GOODWILL INDUSTRIES

GRADING & DRAINAGE PLAN

**GOODWILL INDUSTRIES
GRADING AND DRAINAGE PLAN**

COVER PAGE

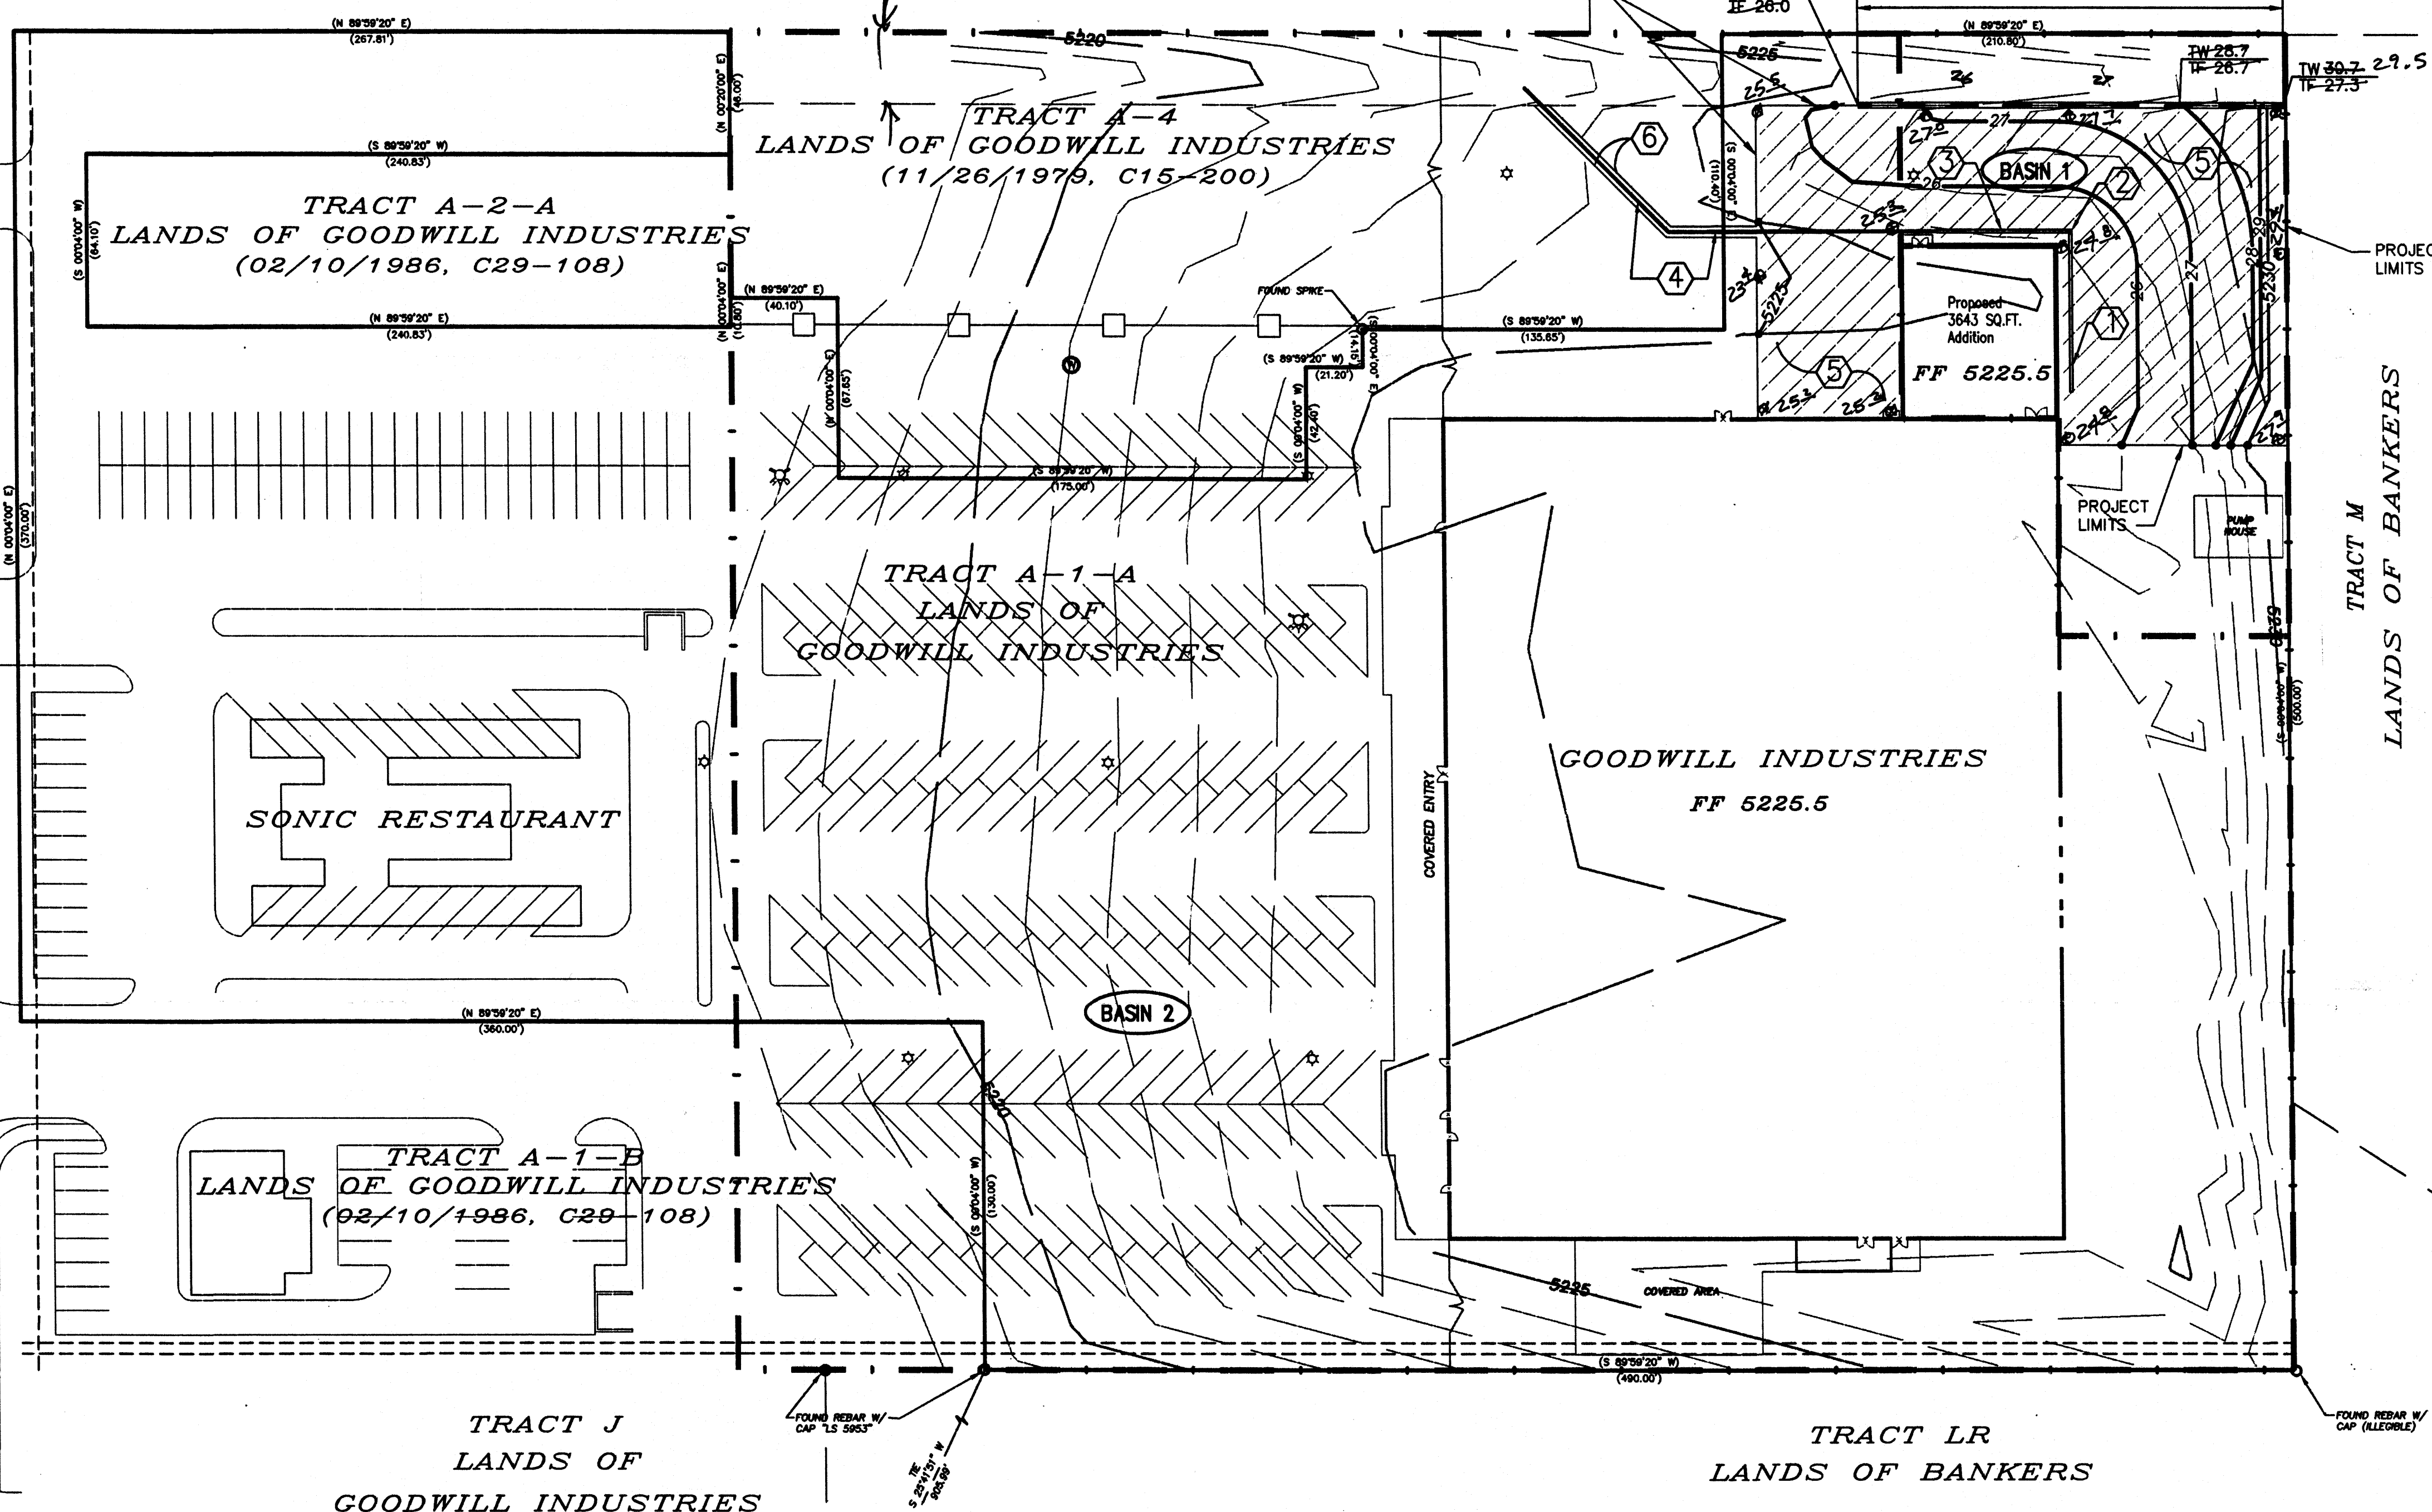
new drainage?
existing street elev?
water block?

Permission to show into dry gulches?

GRADING PLAN

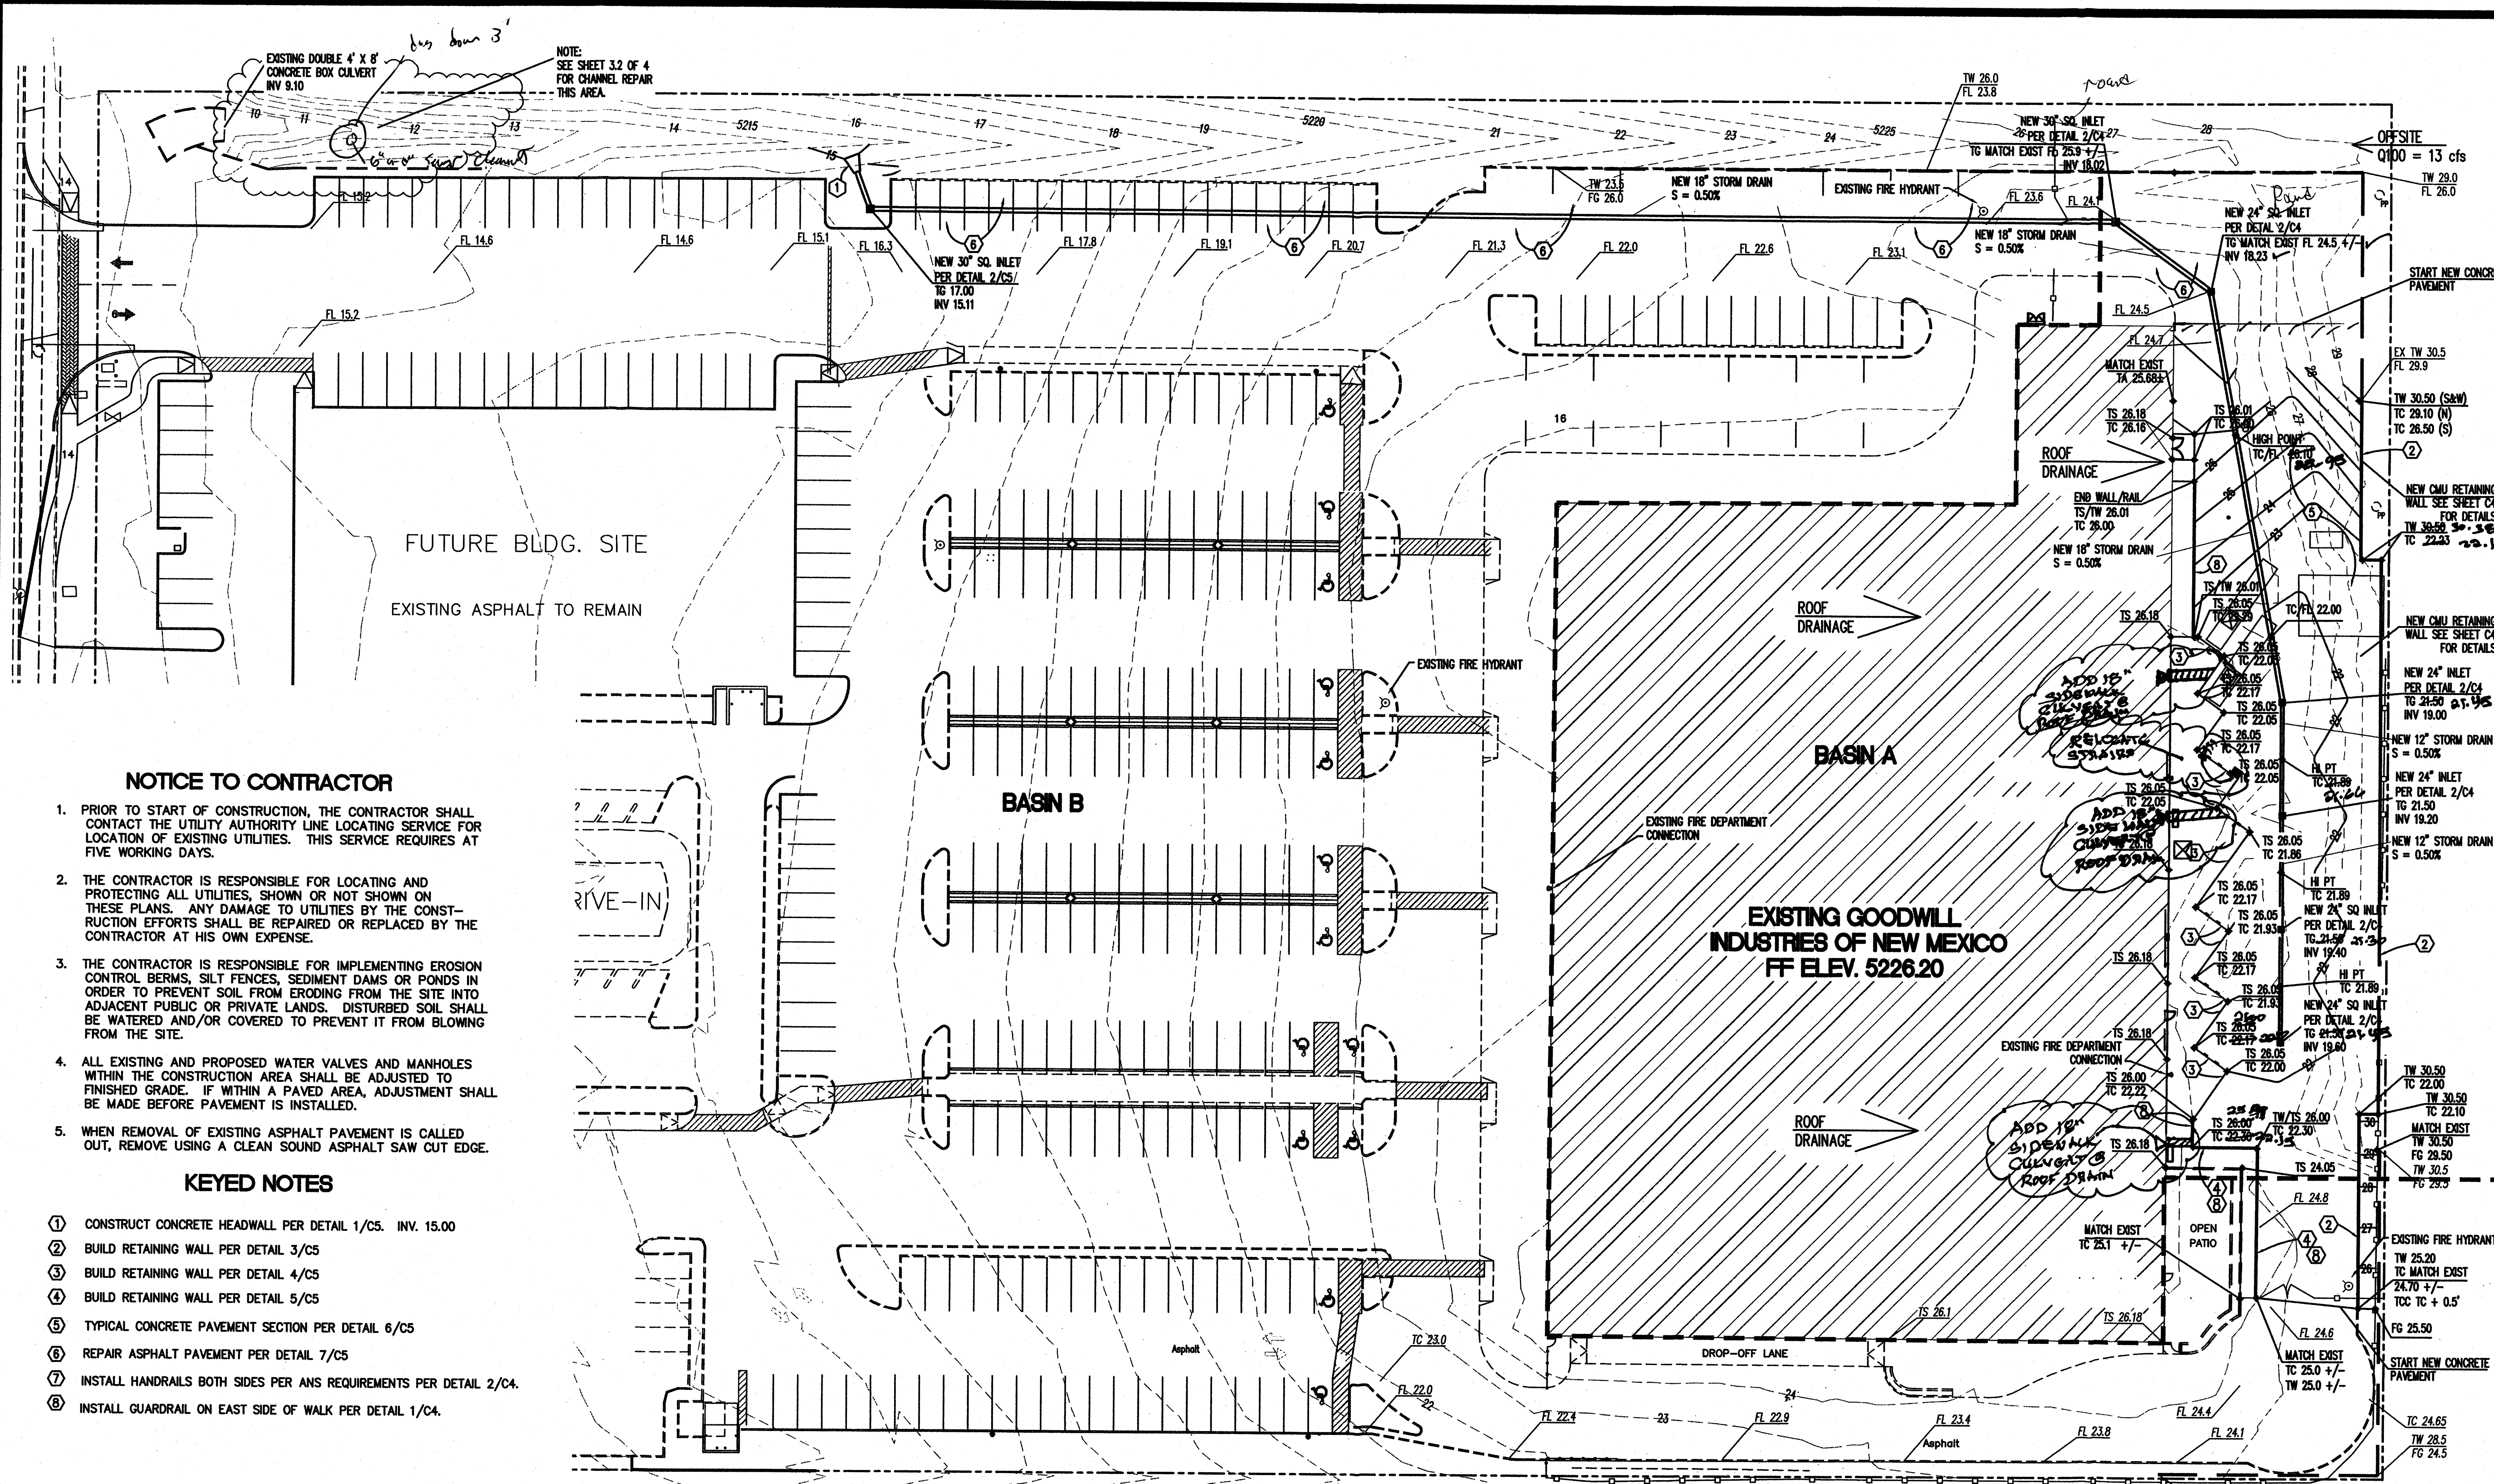
Exceptions: Changes have been edited onto the grading plan and noted. The major change was the addition of 3 - 18" sidewalk culverts in the dock surface to convey roof drainage from the roof drain downspouts, across the dock surface, to the edge of the dock to avoid slick areas and possible ice build-up.
